Re: Harold D. Thompson Regional Water Reclamation Facility (HDTRWRF)
Lower Fountain Metropolitan Sewage Disposal District (LFMSDD)

Submittal No.:	11160-001B
Date of Submittal:	October 31, 2012
Supplemental Information:	November 20, 2012
Title:	Aeration Basin Mixers and Hoist
Specification Section:	11160
Manufacturers:	Grundfos; International Protective Coatings; Halliday Products, Inc.

The referenced submittal has been stamped "***No Exception Taken***" and "***Revise and Resubmit***".
Our comments are as follows:

SERIES M
STAINLESS STEEL MIXER MAST
ASSEMBLY

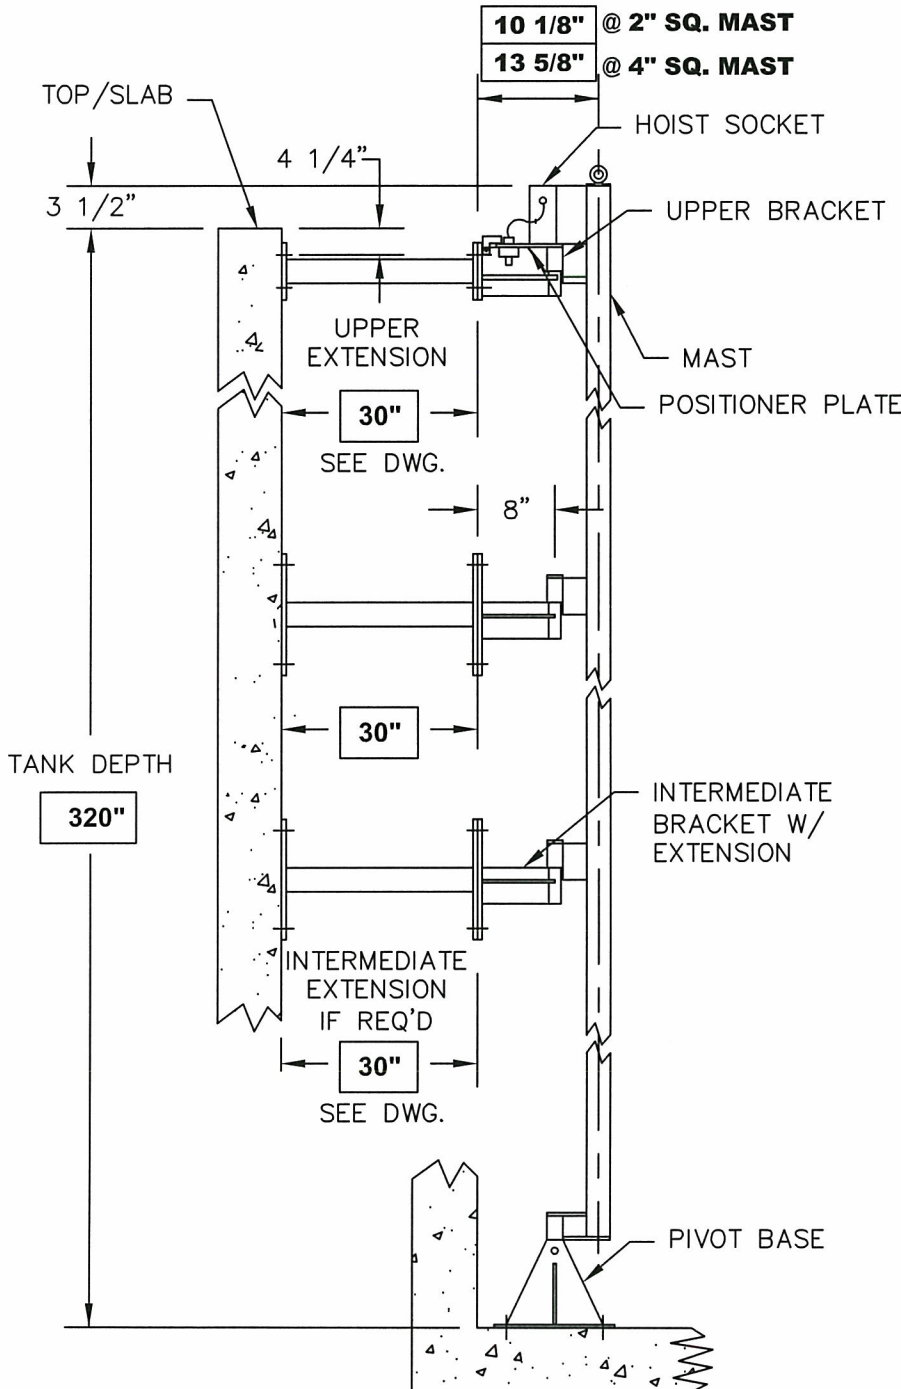
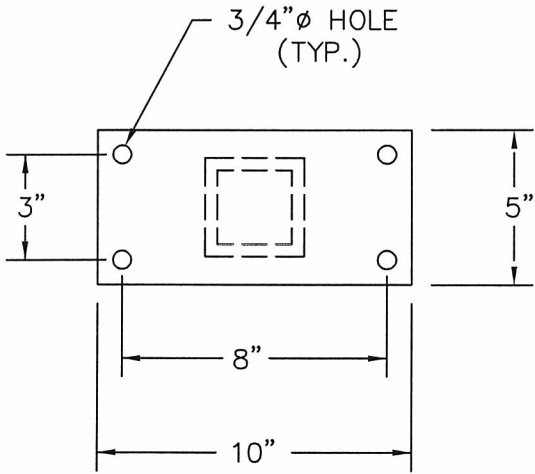
- 1) The submitted mixer mast assembly drawings (3 total) and bracket extension drawings (2 total) still require revision. The mixer mast assembly drawings correctly grouped mixer tag numbers with their corresponding tank depths. However, the bracket extension requirements for specific mixer tag numbers are still incorrect. We again ask that you reference the handwritten notes and color coding given on the two attachment files of the November 6, 2012 email to John Jacob and revise the mixer mast assembly drawings. To further clarify these requirements, here is another detailed description of the five mixer mast assembly drawings that are required for this application.

- Mixer tag numbers: ABM-1, 2, 5, 6, 9
Actual tank depth: 320 inches
Quantity of mast assemblies: 5
Extension distance required: 30 inches
 - Mixer tag numbers: ABM-10
Actual tank depth: 320 inches
Quantity of mast assemblies: 1
Extension distance required: None required

QUANTITY: ~~6~~ 5

MIXERS# 1, 2, 5, 6, 9, ~~10~~

*For Mixer ABM-10
 same tank depth
 applies except
 extensions are
 NOT required.*

HALLIDAY PRODUCTS ORLANDO FL.	
SCALE	NONE	UPPER MIXER BRACKET EXTENSION (4" MAST)	STANDARD
DATE	10/15/12		OLD NO.
REVISED		MATERIAL: S. STL. (T-304)	DWG. NO. W15321 M4CB30A

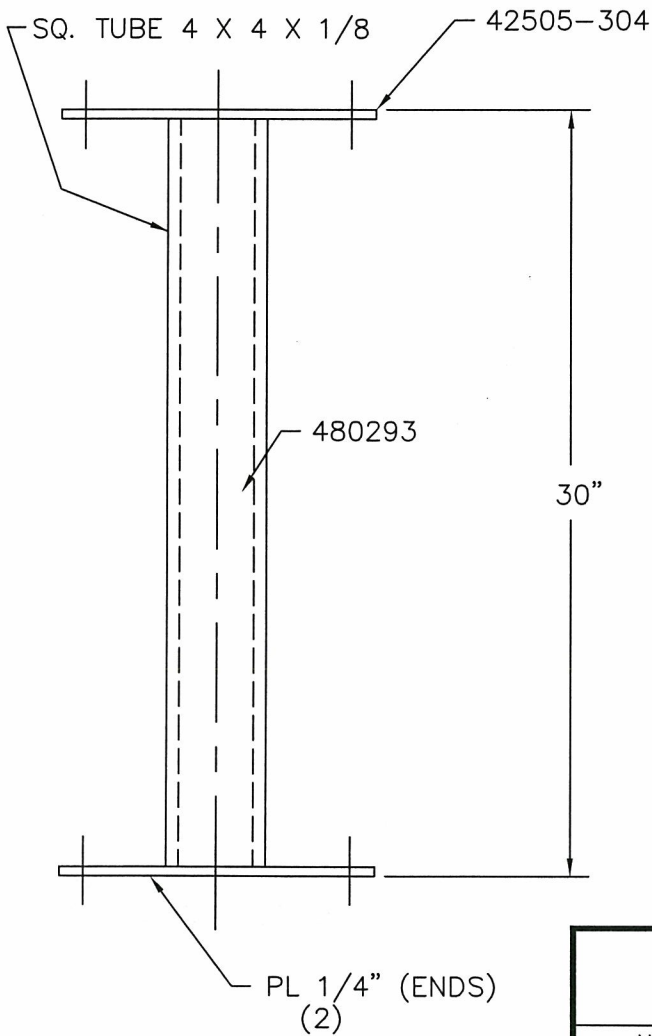
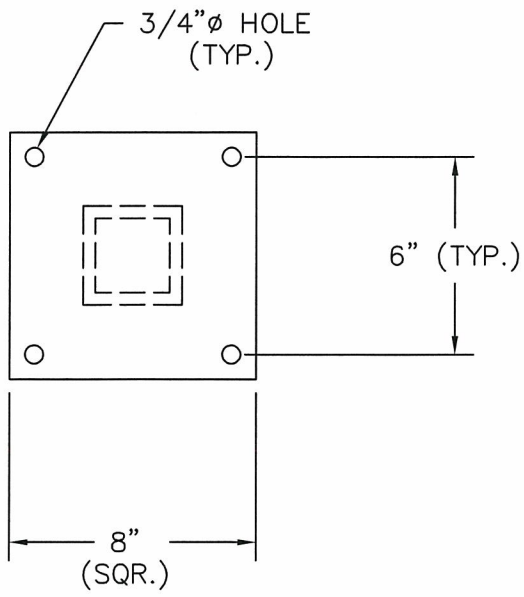
- Mixer tag numbers: ABM-12
Actual tank depth: 324 inches
Quantity of mast assemblies: 1
Extension distance required: None required
 - Mixer tag numbers: ABM-3, 7, 11
Actual tank depth: 325 inches
Quantity of mast assemblies: 3
Extension distance required: 30 inches
- 2) Revise bracket extension drawings to indicate a total of 10 upper bracket extensions required and a total of 20 intermediate bracket extensions required. Mixer tag numbers requiring extension brackets: ABM-1, 2, 3, 4, 5, 6, 7, 8, 9, 11.
- d. Comment No. 4 regarding vertical location of upper mast bracket and associated anchor bolts: **No Exception Taken**
4. We are also attaching select pages of the supplemental information to this letter. There were numerous pages included in the supplemental information. However, we are only attaching those pages that are pertinent to the remaining issues.

SERIES M
STAINLESS STEEL MIXER MAST
ASSEMBLY

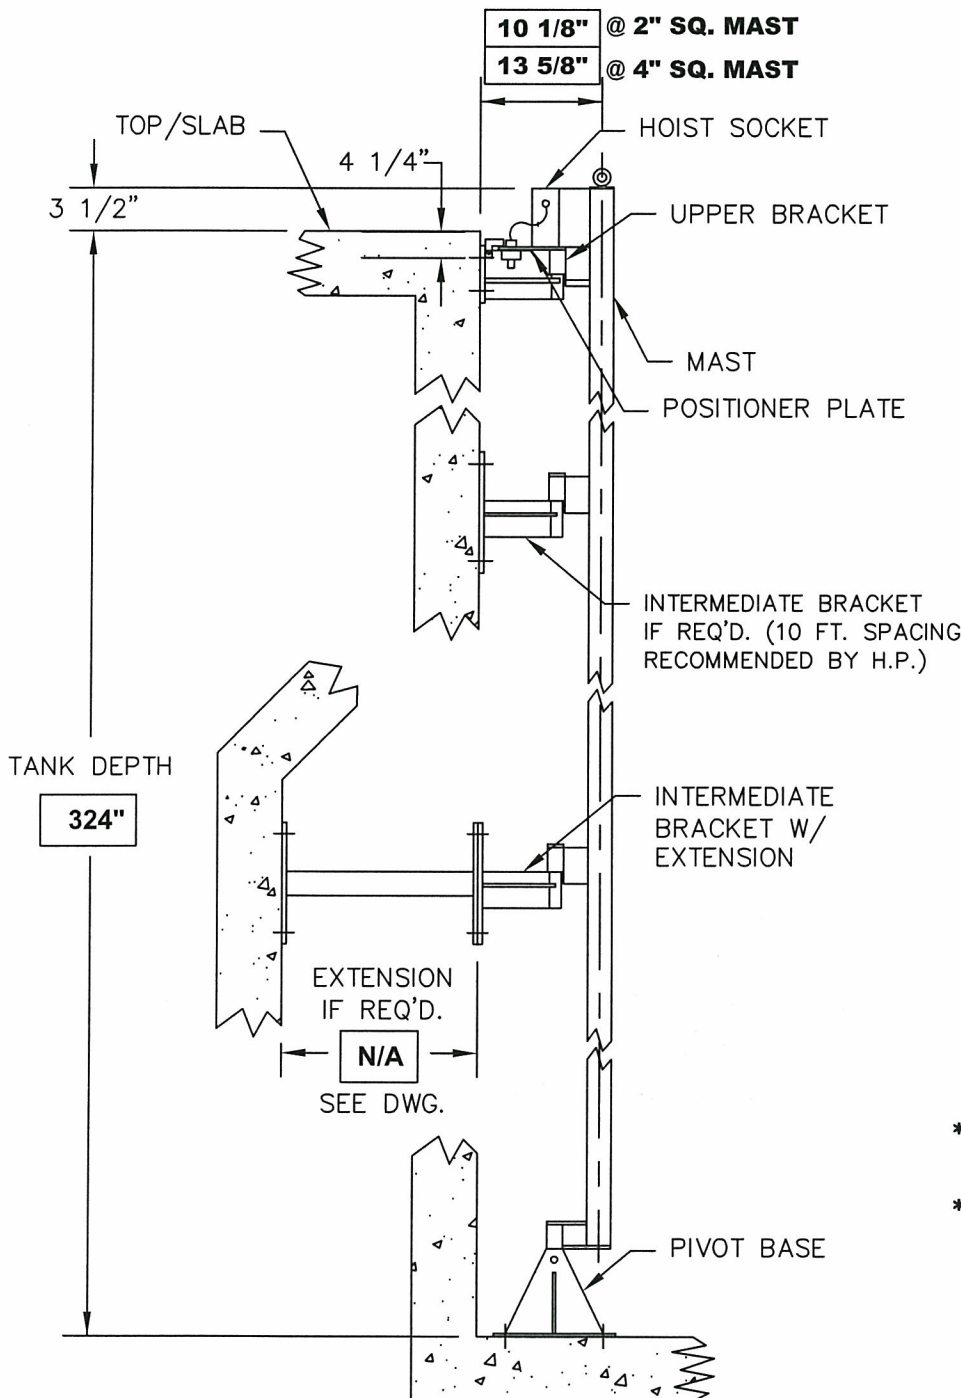
- Mixer tag numbers: ABM-4, 8
Actual tank depth: 324 inches
Quantity of mast assemblies: 2
Extension distance required: 30 inches

*For Mixers ABM-4
 and ABM-8, same
 tank depth applies
 except extension
 required = 30"*

SERIES M
STAINLESS STEEL MIXER MAST
ASSEMBLY

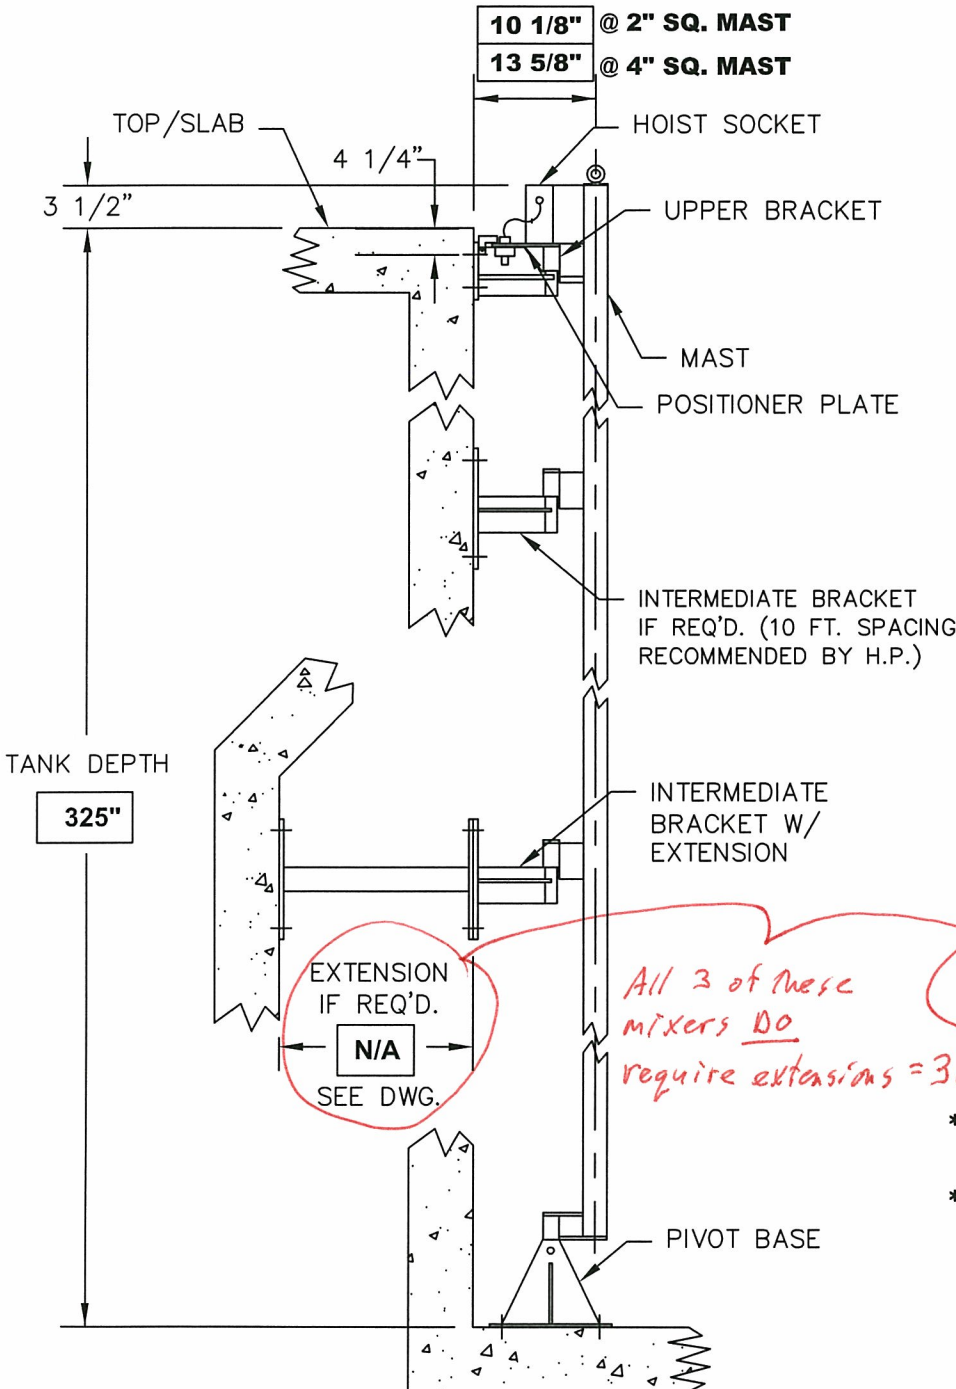
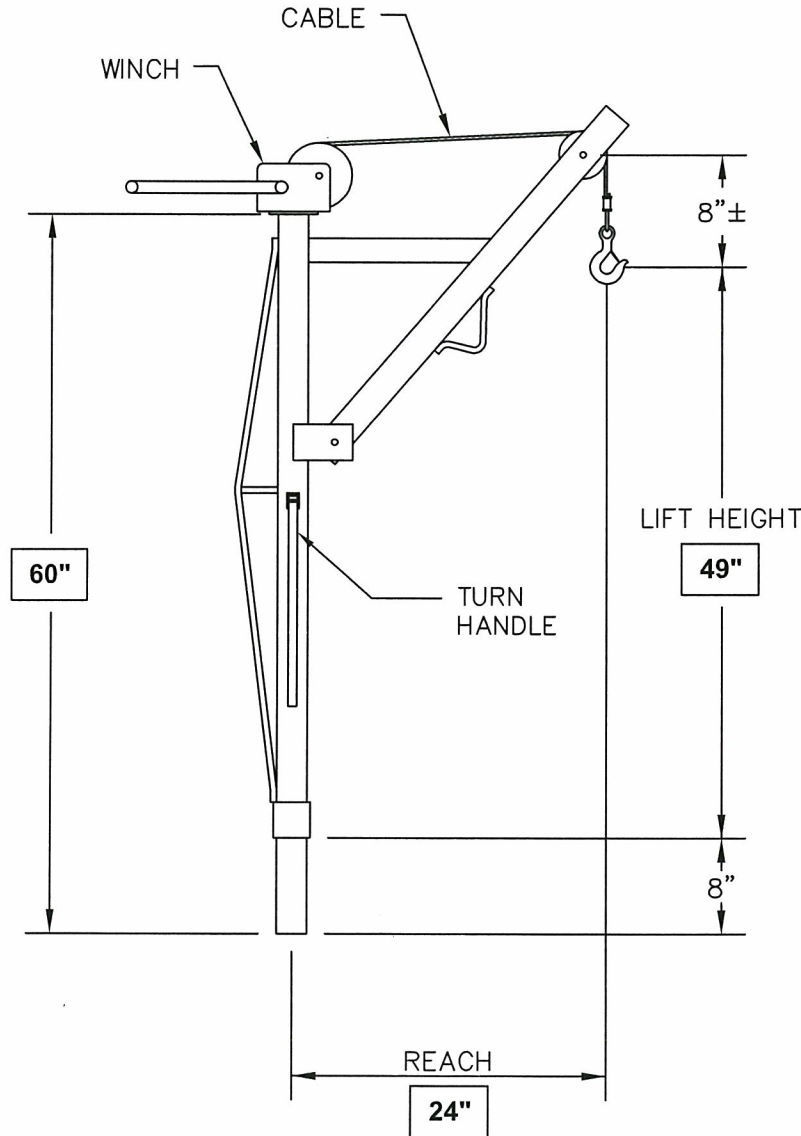
All 3 of these mixers DO require extensions = 30"

Designed By: D. McGregor	Drawn By: D. McGregor	Title: S480 3Ø Mixer Panel
Approved By:	Drawing: 1 of 1	Drawing No. <Submittal/Exterior>
Date Approved:	Revision: 1.1	Date: 10/30/12
		Scale: 1" = 3.5"

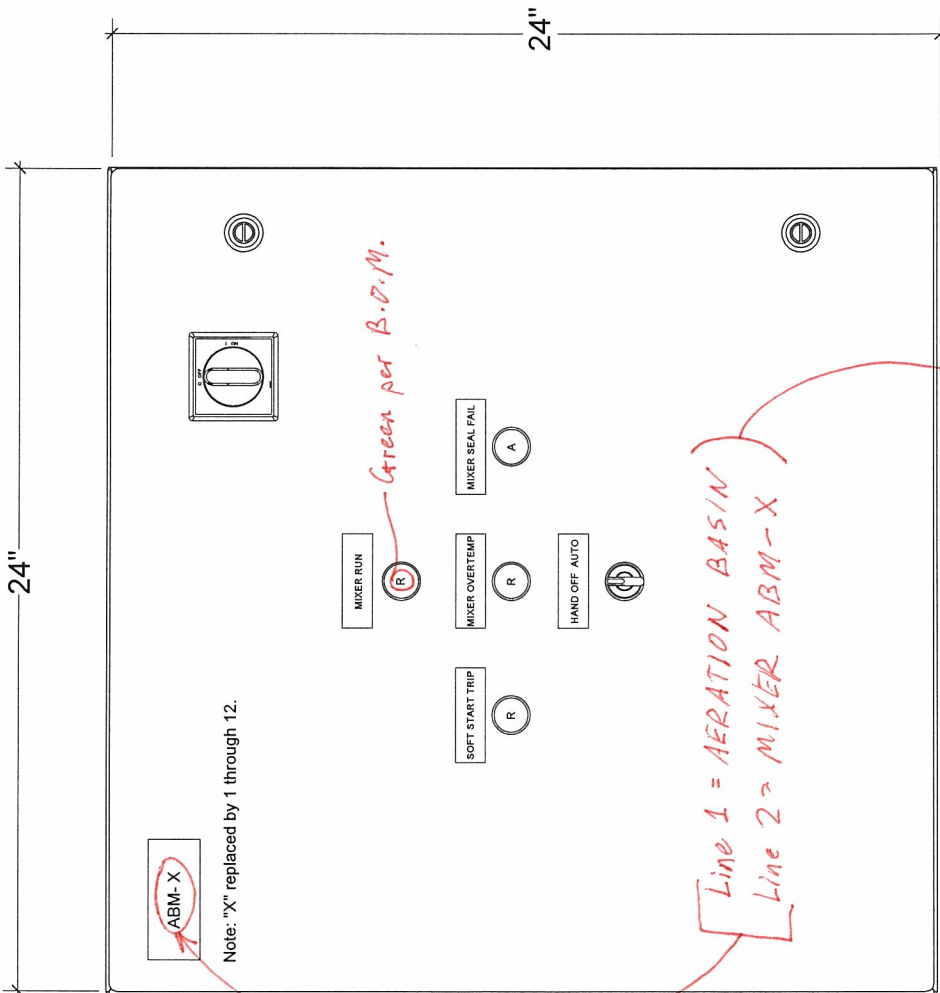
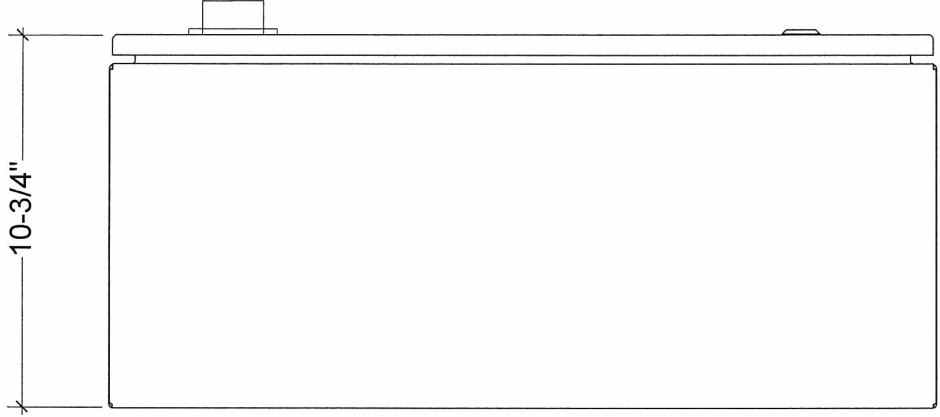
- a. Comment No. 1 regarding the NEMA rating of individual control panel components: **No Exception Taken**
- b. Comment No. 2 regarding the control panel contact requirements: No exception is taken to the wiring diagram revisions including with the supplemental information. However, two items require correction on the submitted exterior control panel drawing.

- 1) Revise the equipment identification plates to have two lines of text. The first line shall read "AERATION BASIN" and the second line shall read "MIXER ABM-X", as was requested in review comment No. 4.d. for Shop Submittal No. 11160-001 and acknowledged by the supplier's response in Shop Submittal No. 11160-001A.

- 2) Revise the mixer run indicating light from red to green, as indicated in the submitted Bill of Materials.
- c. Comment No. 3 regarding the mixers and their corresponding mast fabrication details: **REVISE AND RESUBMIT**

as requested in review comment no. 4.d. for Shop Submittal No. 11160-001 and acknowledged by supplier's response in Shop Submittal No. 11160-001A.

DESIGNED BY: GMS, INC.
 CHECKED BY: [Name]
 PROJECT NO.: 2018.04.02
 SHEET NO.: AB-11
 OF 11

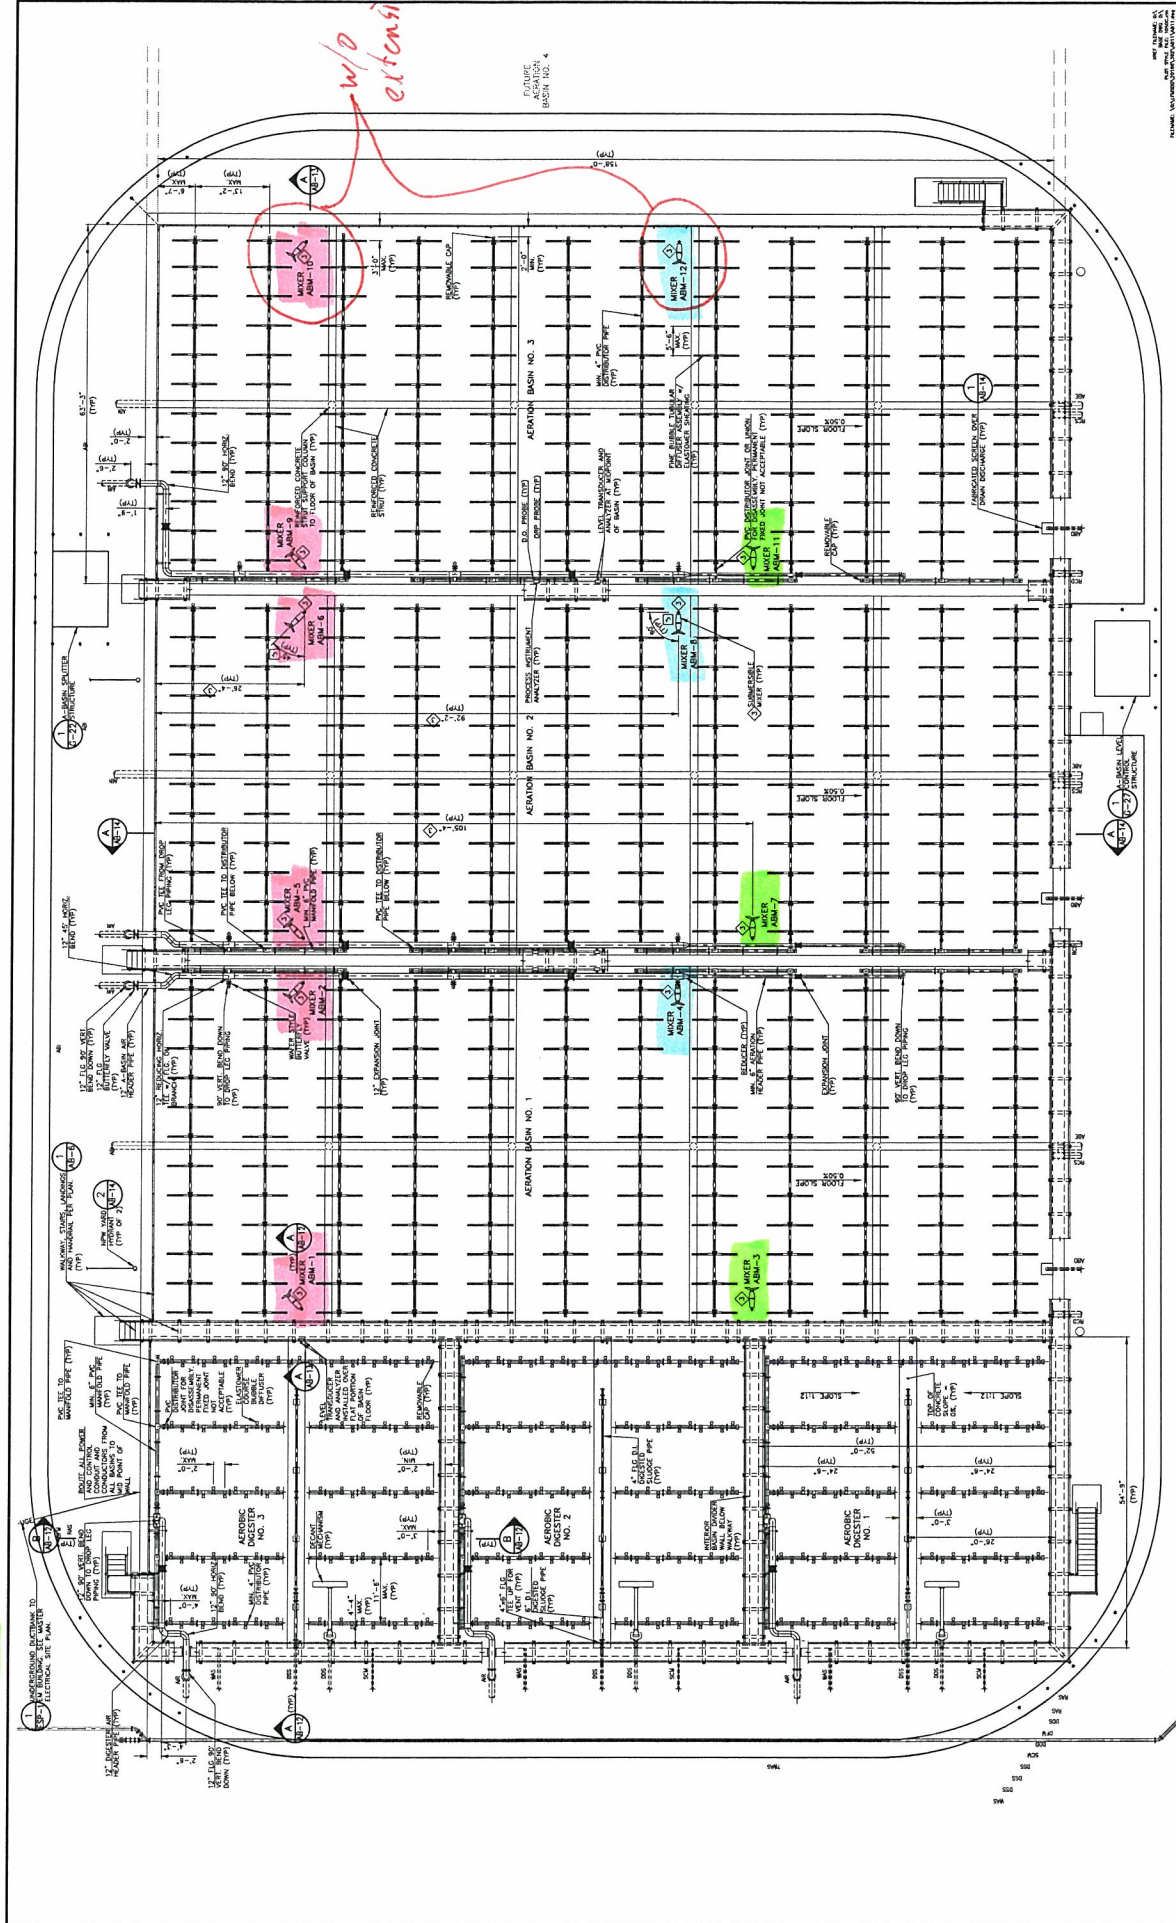
3. Comment No. 7: Attached is my tally of mixer mast lengths and required mast bracket extensions handwritten on AB-11, as well as my mixer tag number listing on Detail 1/AB-13. It seems to me that my responses to the mixer mast inquiry form that I sent to you on 9-5-12 still have not been accounted for in this 11160-001B submittal. The 11160-001B submittal responses are still not addressing the mixers according to tag numbers as was requested, which were shown on the AB-11 drawing that was included in my email response to you on 9-5-12.

As you can see, my attached tally was based on this 9-5-12 version of AB-11 so the mixer tag numbers can be correlated to the mast lengths and bracket extension requirements. Note the north arrow direction on AB-11, it is "to the right" on the drawing. It seems the 11160-001B responses may be assuming north is "up" on the drawing. Please review the attached drawings with your supplier. If it was a simple misunderstanding of the north direction and you both agree with my tally, then you can revise the submittal drawings accordingly. But you must be sure that you and your supplier confirm and agree on whatever tally you submit as final. I have a feeling you may need to resubmit the mixer mast assembly drawings with the correct quantities, tag number designations and mast lengths in response to our previous review comment no. 7.

Floor el. = 86.61 → most length = 326 → quant. = 6 total, 1 w/o extensions
 Floor el. = 85.74 → most length = 324 → quant. = 3 total, 1 w/o extensions
 Floor el. = 85.67 → most length = 325 → quant. = 3 total
